Product Change Notification

Change Notification #: 108511 - 00
Change Title: Intel ® Carrier Grade Server TIGW1U and Intel ® Server Spare TMWFANSET01W, PCN 108511-00, Product Material, Changed CPU Fan Wire Routing, modifications allowing support for 2.5 inch SATA Hard Drives
Date of Publication: May 28, 2008

From cable side routing:

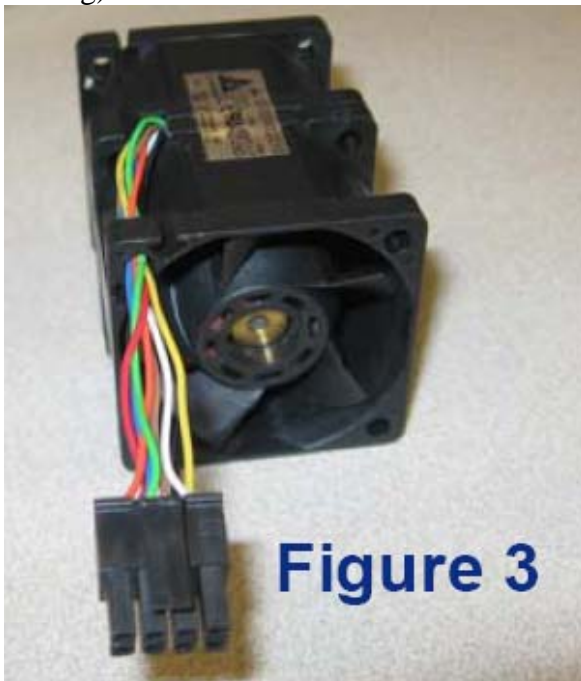
This PCN notifies that Intel has changed the CPU fan by modifying the position of wiring from the side retention (Figure 1), or top retention (Figure 2), to a route through an unused mounting hole (Figure 3) for TMRA0201W, TMRD0201W, and TMWFANSET02W. Wiring had potential to be misrouted, or to escape retention, or to be routed through the wrong retention site (figure 2).

Note: Figure 2 is still correct position for the TMWA0201W or TMWD0201W product code servers.

To cable routing through the unused fan mounting hole cable routing (this is the new routing):

Figure 4. Cable placement changed from this:

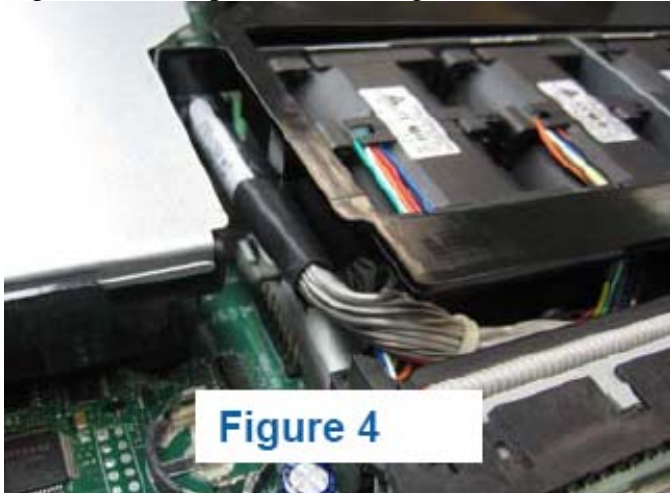
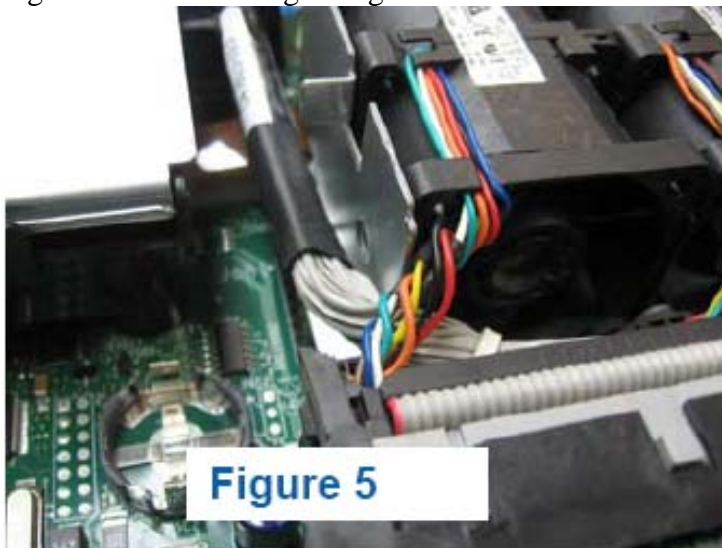
Changed the routing of the fan wire for the centermost CPU fan from under the CD IDE cable (Figure 4) to over the CD IDE cable (Figure 5). This change ensures that the IDE cable is not compressed against the sheet metal at the top of the chassis, and reduces the transmission of vibration from the fans to the drive bays.

Figure 5. Cable routing changed to this:
